Proposed Remedy for comment # 28 clause 33.2.8.5page 109 line 20

Figure 33-26 – linrush-2P and linrush current and timing limits, per pairset in POWER_UP state

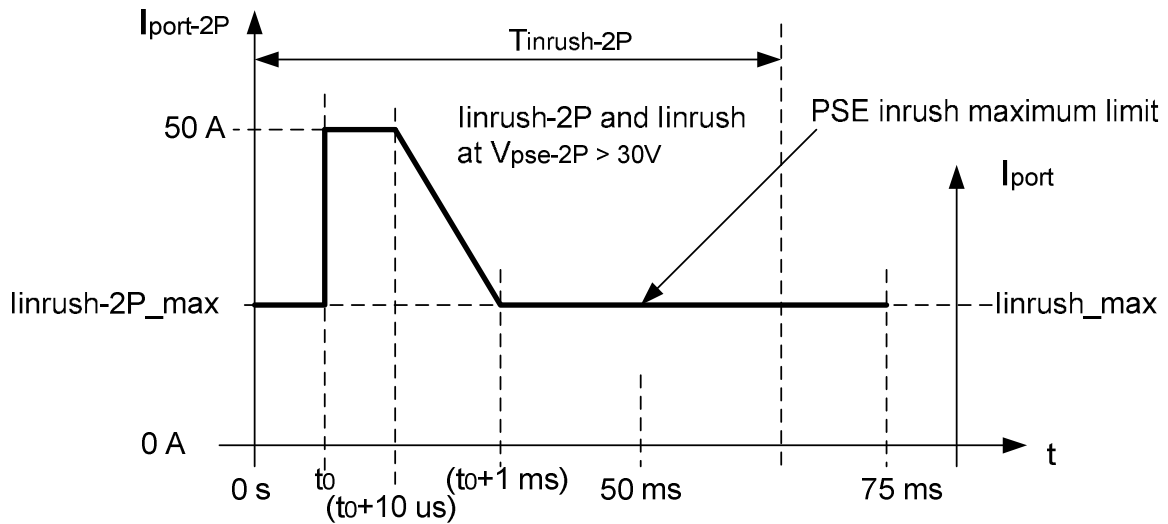
1. To change Figure 33-26 to:

2. To update equation 33-14 to fit new Figure 33-26.

Change the range of the 1st line of the equation to: $t_0 < t < (t_0 + 10.0 \times 10^{-6})$

Change the range of the 2nd line of the equation to: $(t_0 + 10.0 \times 10^{-6}) < t < (t_0 + 0.001)$

Change the equation of the 2nd line to: $a \times (t + t_0) + b$

Change the range of the 3rd line of the equation to: $(t_0 + 0.001) < t < 0.0075$

Add new range *before* the 1st line with the following equation: I_m for $0 < t < t_0$

Add to the “where” list of parameters:

t_0 Is the time when $I_{port-2P}$ exceeds $I_{inrush-2P_max}$ for the first time during POWER_UP.

$$a = -\frac{(50 - I_m)}{99 \times 10^{-5}}$$

$$b = 50 - a \times (t_0 + 10^{-5})$$
